PLANNED UNIT DEVELOPMENT &

SUBDIVISION STAFF REPORT Date: March 1, 2007

DEVELOPMENT NAME The Woodlands at The Preserve Subdivision,

LOCATION 3532 Rue Royal

SITE PLAN

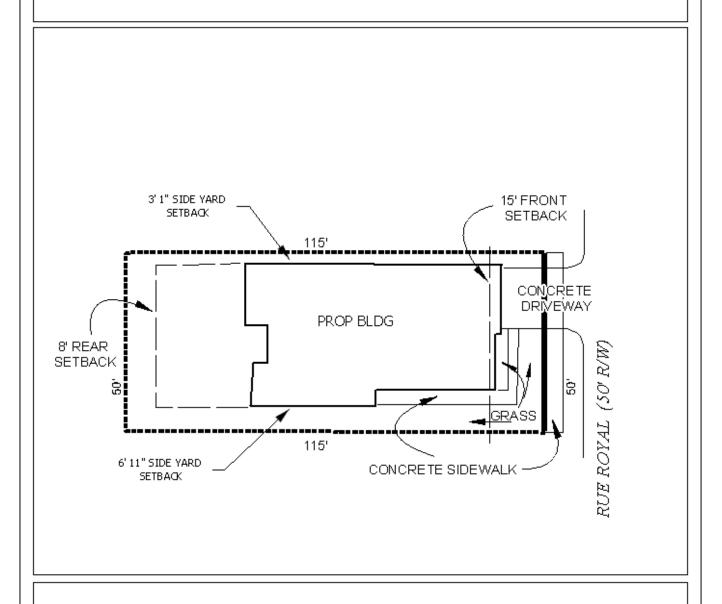
Site plans submitted for the construction of the dwelling illustrated 15-feet setback on the front property line. However, "as built" plans illustrate the dwelling was constructed 12-feet from the front property line.

Planned Unit Development Based on the preceding, this application is recommended for Tentative Approval, subject to the following conditions: 1) revision of the site plan to illustrate the amendment of the front yard setback for Lot 34; and 2) compliance with all municipal codes and ordinances.
